Re: Seq. III CPD Technical Memo 13  
OHT3F-053/054/055-1, BATCH CODE 21, PISTONS- INCORRECT ETCHING

**OHT3F-053/054/055-1, BATCH CODE 21, TEST PISTONS- INCORRECT ETCHING**

**INCORRECTLY MARKED  
GRADE 56 PISTON**

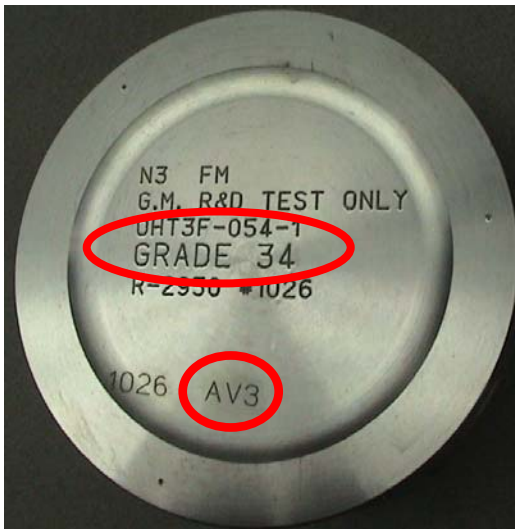
Please be advised that there are OHT3F-055-1 Grade 56 test pistons that have been incorrectly etched as OHT3F-054-1 Grade 34 Pistons. The parts in question are limited to Batch Code 21. This issue was brought to our attention by a laboratory that received Grade 34 pistons in a box labeled as Grade 56 material.

“AV3” INDICATES THIS IS **GRADE 56**

Piston grade for all runs of Batch Code 21 material should be confirmed by comparing the “Grade” designation with the “AV” number etched below the historical information on each piston. The following table indicates the correct correlation between these markings:

In cases where these markings do not correlate, please return this material to OH Technologies, Inc. for immediate replacement. Do not use pistons with improper markings.

**CORRECTLY MARKED  
GRADE 34 PISTON**

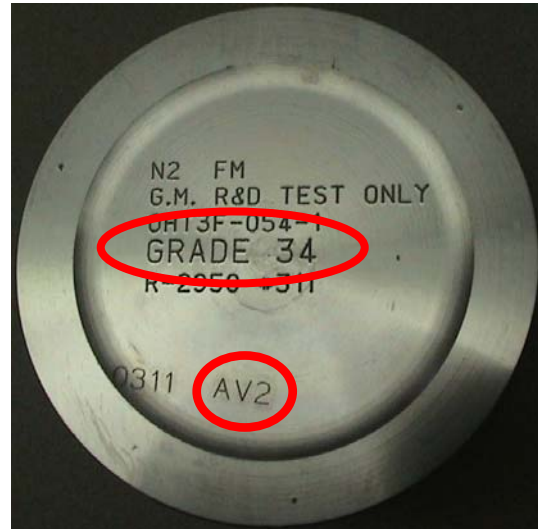
“AV2” INDICATES THIS IS **GRADE 34**
